MITSUBISHI HEAVY INDUSTRIES, LTD.
16-5, KONAN 2-CHOME, MINATO-KU
TOKYO, JAPAN

Docket No. 52-021
MHI Ref: UAP-HF-11091

Subject: Transmittal of the Updated Tier 2, Chapters 9, 10 and 12 of US-APWR DCD

Update of Tier 2, Chapter 9 of US-APWR DCD

Figure 9.2.6-1 Condensate Storage Facilities System Flow Diagram

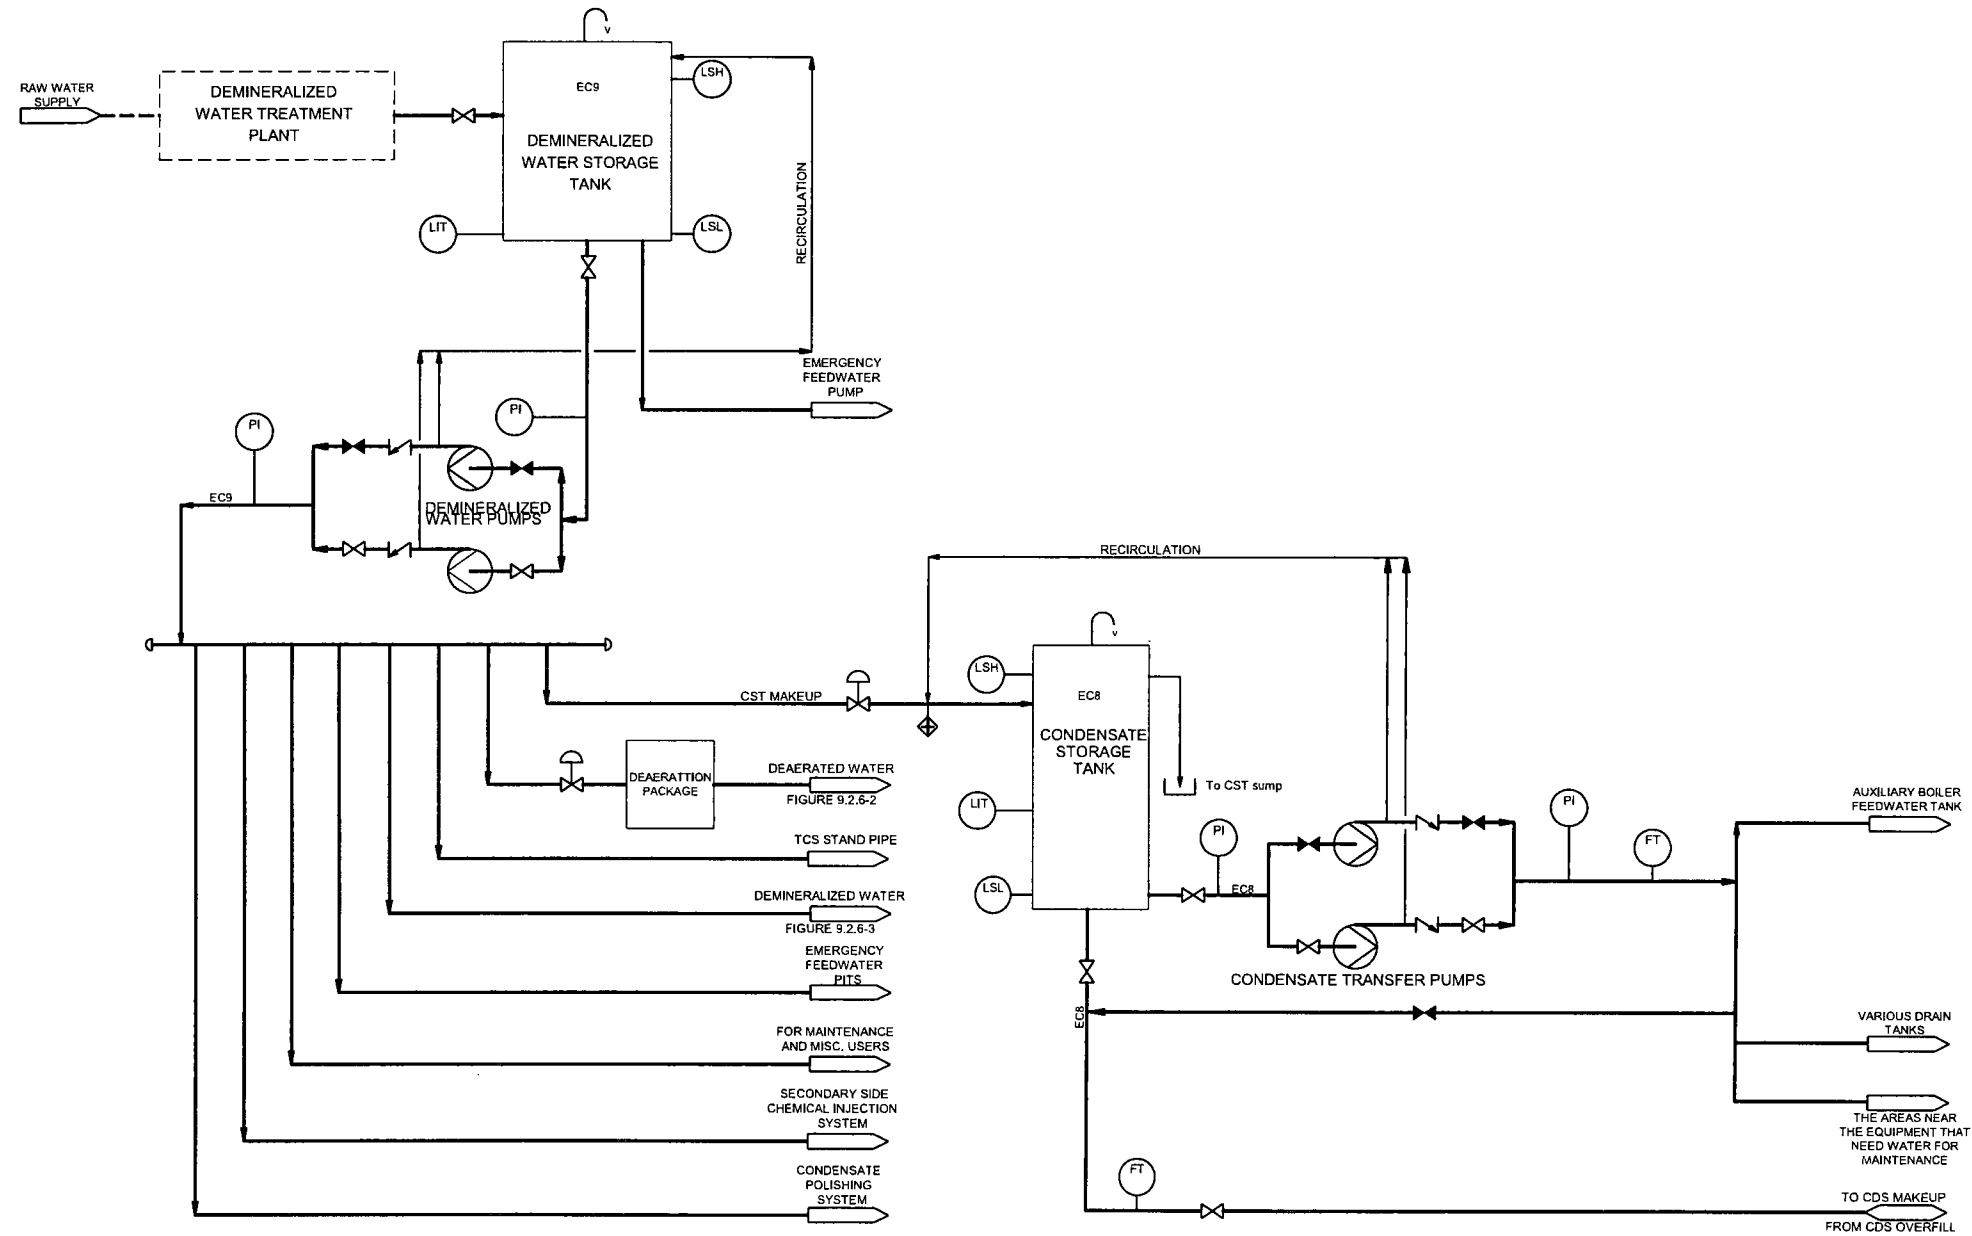
The CST is the normal source of water for make up to certain plant systems including the main condenser. The CST is a source of water for supply to various locations such as areas near equipment that need water for maintenance and drain tanks. Makeup to the CST is provided from the DWST. The CST overflow goes to a dike which is provided to control the release of chemicals and radioactive materials. This CST overflow is directed to the Condensate Storage Tank sump inside the dike area. The sump is equipped with a level instrument to detect fluid level and initiates alarms via representative alarm in the MCR for operator actions to stop condensate transfer and to investigate the extent of condition. After analysis for level of contamination, the content inside the dike area can be trucked to WWS for disposal; or to the LWMS for treatment and release.

RCOL2_12.0
3-12.04-11
S02
